CITY OF ALBUQUERQUE

Re: Farolito Senior Community
10501 Central Ave. NE
Traffic Circulation Layout
Engineer's/Architect's Stamp XX-XX-XX (L21-D074)

Based upon the information provided in your submittal received 08-15-23, the above referenced plan cannot be approved for Building Permit until the following comments are addressed:

TRAFFIC
CIRCULATION
PLAN

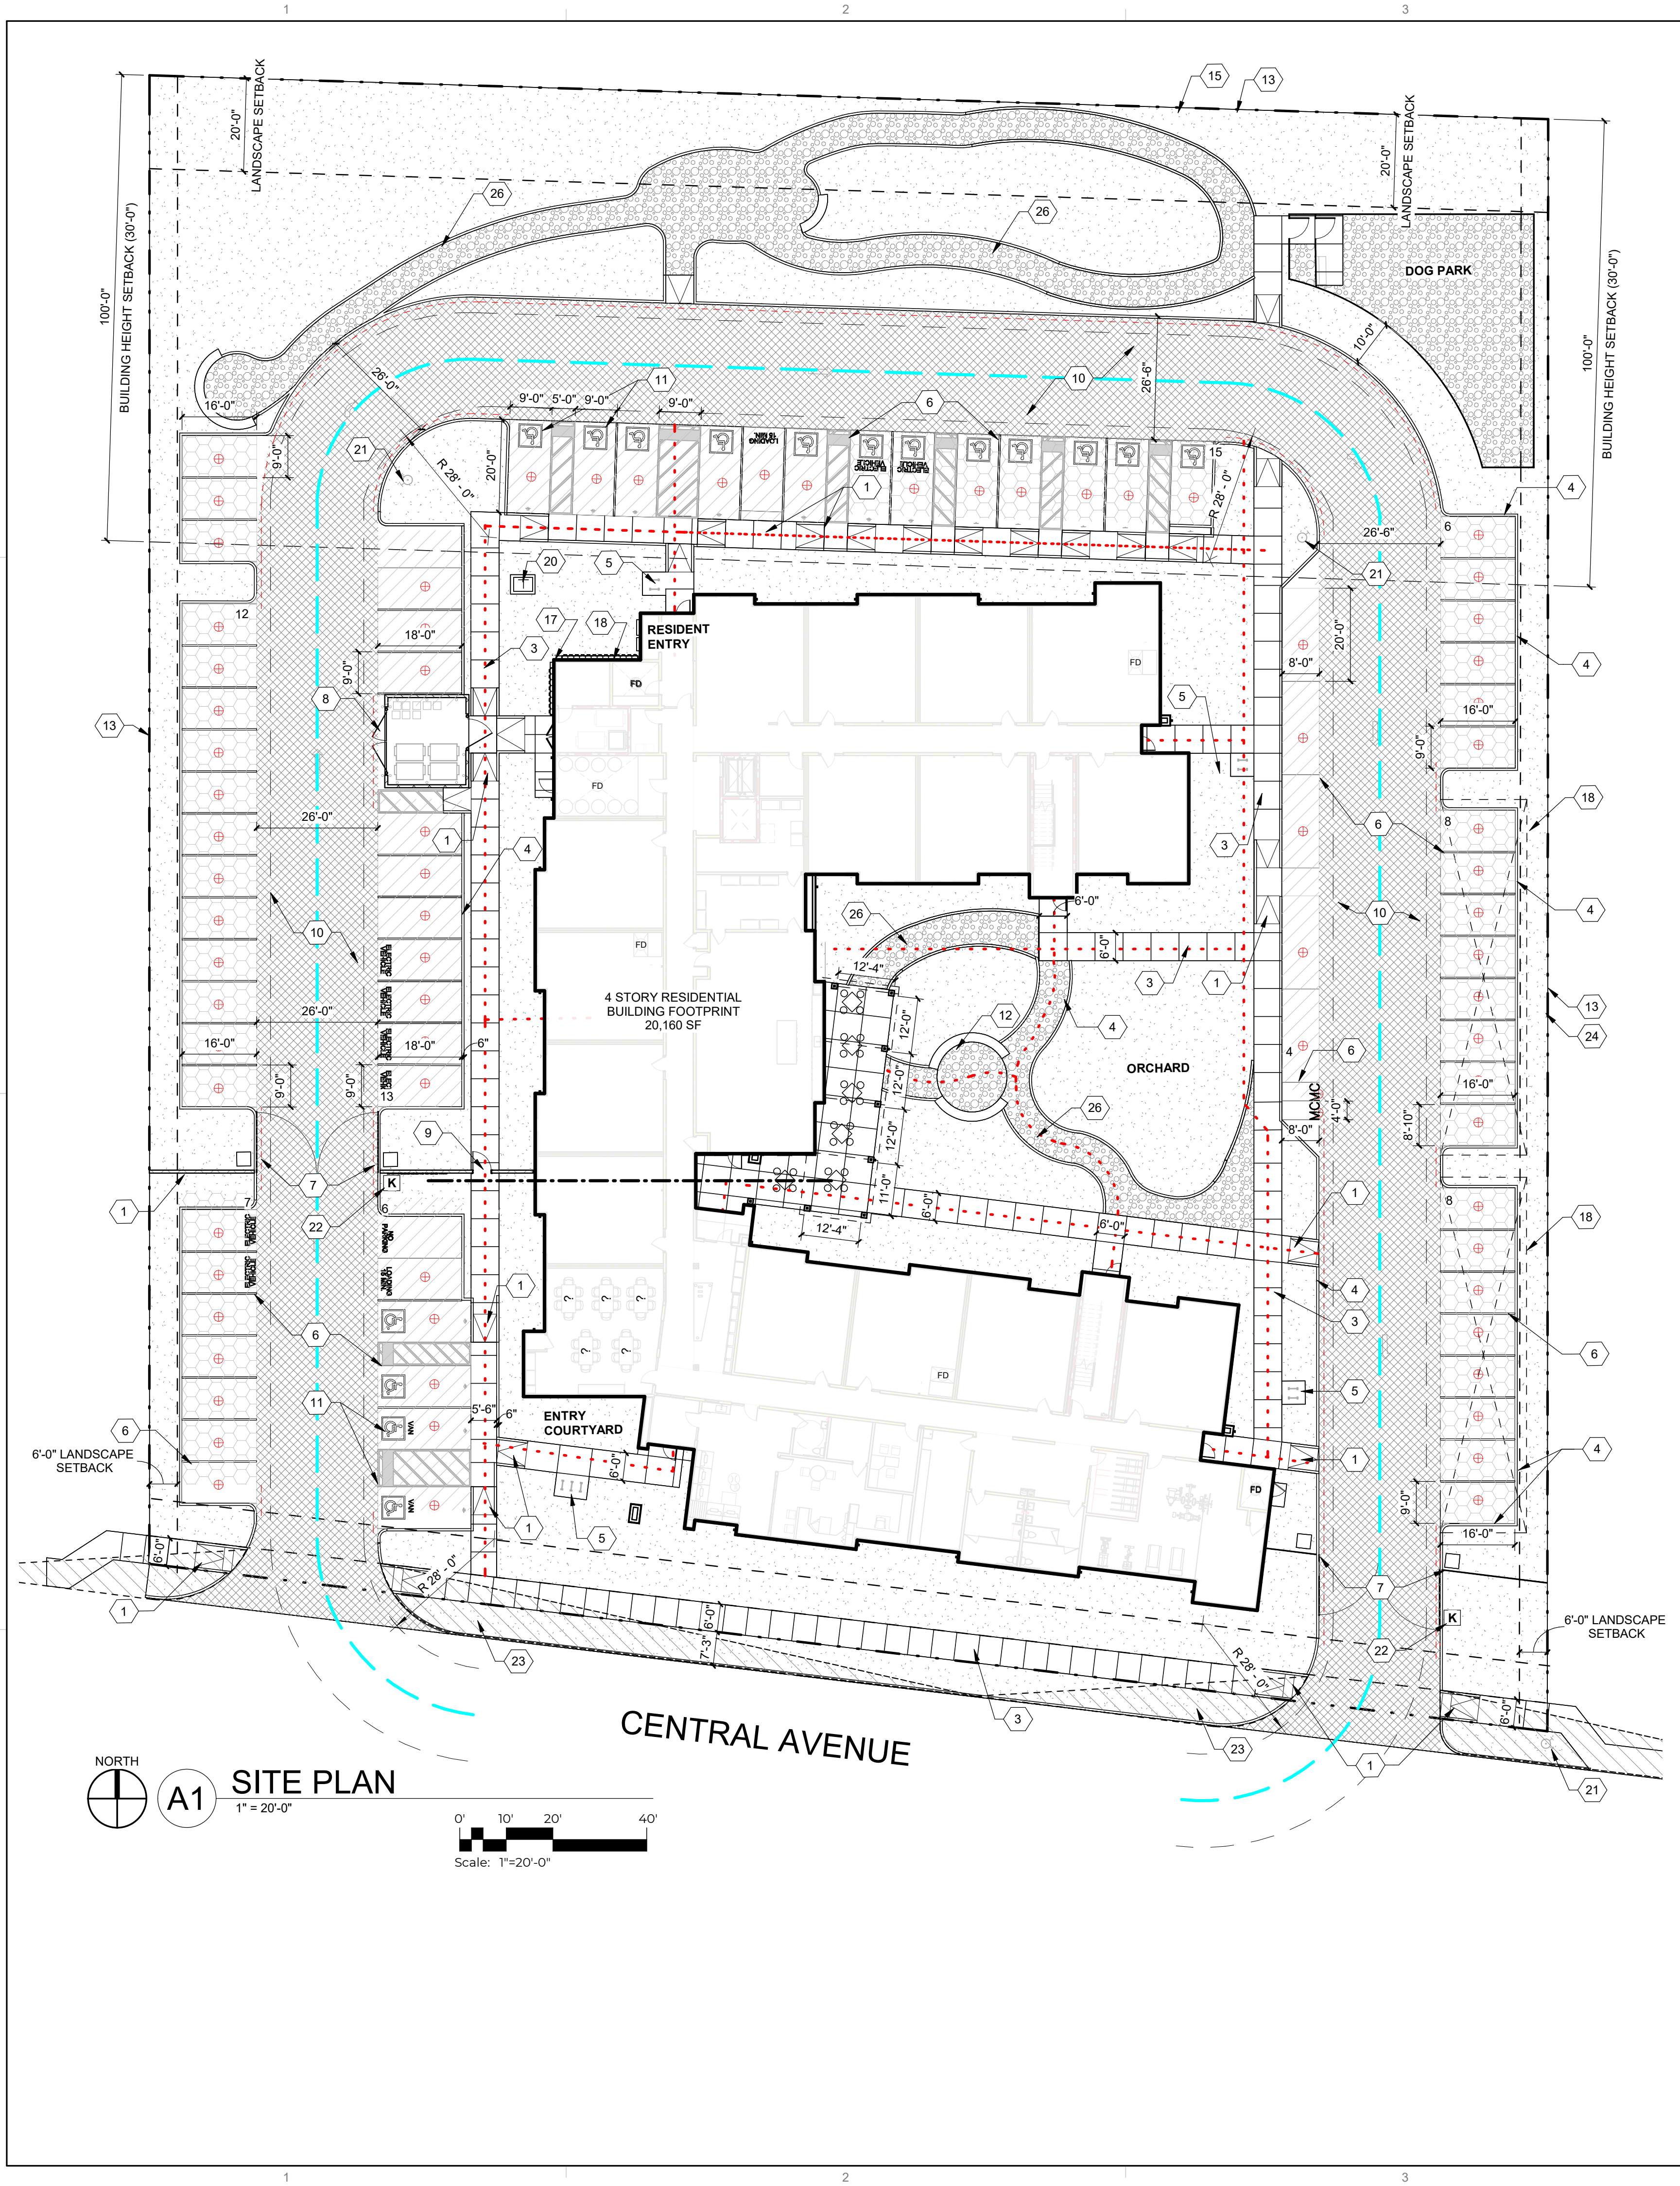
1. The traffic circulation layout must be stamped, signed, and dated by an engineer or architect licensed in the state of New Mexico.
2. Identify all existing access easements and rights of way width dimensions.

3. Identify the right of way width, medians, curb cuts, and street widths on Central Ave.
4. The Minimum throat length for both site accesses is 50 ft. please show this dimension on the site plan.

5. Due to propose 6' wide sidewalk, please clarify the status of the existing light poles.
6. Please provide sidewalk easement.
7. The Minimum parking space length is 18 ft. Please revise the site plan.

8. Details sheet is missing.
9. Please provide details for all the proposed ADA ramps.
10. The ADA accessible parking sign must have the required language per 66-7-352.4C NMSA 1978 **"Violators Are Subject to a Fine and/or Towing."** Please call out detail and location of signs.

11. The ADA access aisles shall have the words **"NO PARKING"** in capital letters, each of which shall be at least one foot high and at least two inches wide, placed at the rear of the parking space so as to be close to where an adjacent vehicle's rear tire would be placed. (66-1-4.1. B NMSA 1978)

12. Motorcycle parking spaces shall be designated by its own conspicuously posted upright sign, either free-standing or wall mounted per the zoning code.

13. The pavement marking "MC" should be shown in the opposite direction for motorcycles entering the parking space.
14. All bicycle racks shall be designed according to the following guidelines:

- a. The rack shall be a minimum 30 inches tall and 18 inches wide.

- b. The bicycle frame shall be supported horizontally at two or more places. Comb/toaster racks are not allowed.
 - c. The rack shall be designed to support the bicycle in an upright position. See the IDO for additional information.

- d. The rack allows varying bicycle frame sizes and styles to be attached.
 - e. The user is not required to lift the bicycle onto the bicycle rack.
 - f. Each bicycle parking space is accessible without moving another bicycle.

15. Bicycle racks shall be sturdy and anchored to a concrete pad.
16. A 1-foot clear zone around the bicycle parking stall shall be provided.
17. Bicycle parking spaces shall be at least 6 feet long and 2 feet wide.

18. Per the IDO, a 6 ft. wide ADA accessible pedestrian pathway is required from the public sidewalk to the building entrances. Please clearly show this pathway and provide details.

19. Per DPM, a 6 ft. wide ADA accessible pedestrian pathway is required from the ADA parking stall access aisles to the building entrances. Please clearly show this pathway and provide details.

20. ADA accessible pedestrian pathway should not be placed behind parking space or adjacent to a vehicular way. Vehicle and pedestrian/wheel chair conflicts should be avoided as much as possible.

21. Refuse vehicle maneuvering shall be contained on-site. The refuse vehicle shall not back into the public right of way.; provide a copy of refuse approval.

22. Provide a copy of Fire Marshal approval.
23. Show the Intersection clear site triangle for the west side site access.
24. Show the clear sight triangle and add the following note to the plan: "Landscaping and signage will not interfere with clear sight requirements. Therefore, signs, walls, trees, and shrubbery between 3 and 8 feet tall (as measured from the gutter pan) will not be acceptable in the clear sight triangle.

25. Please specify the City Standard Drawing Number when applicable.
26. Work within the public right of way requires a work order with DRC approved plans.

27. Please add a note on the plan stating "All improvements located in the Right of Way must be included on the work order."
28. Traffic Studies: See the Traffic Impact Study (TIS) thresholds. In general, a minimum combination of 100 vehicles entering and exiting in the peak hour warrants a Traffic Impact Study. Visit with Traffic Engineer for determination, and fill out a TIS Form that states whether one is warranted. In some cases, a trip generation may be requested for determination (**Contact Matt Grush: mgrush@cabq.gov**).
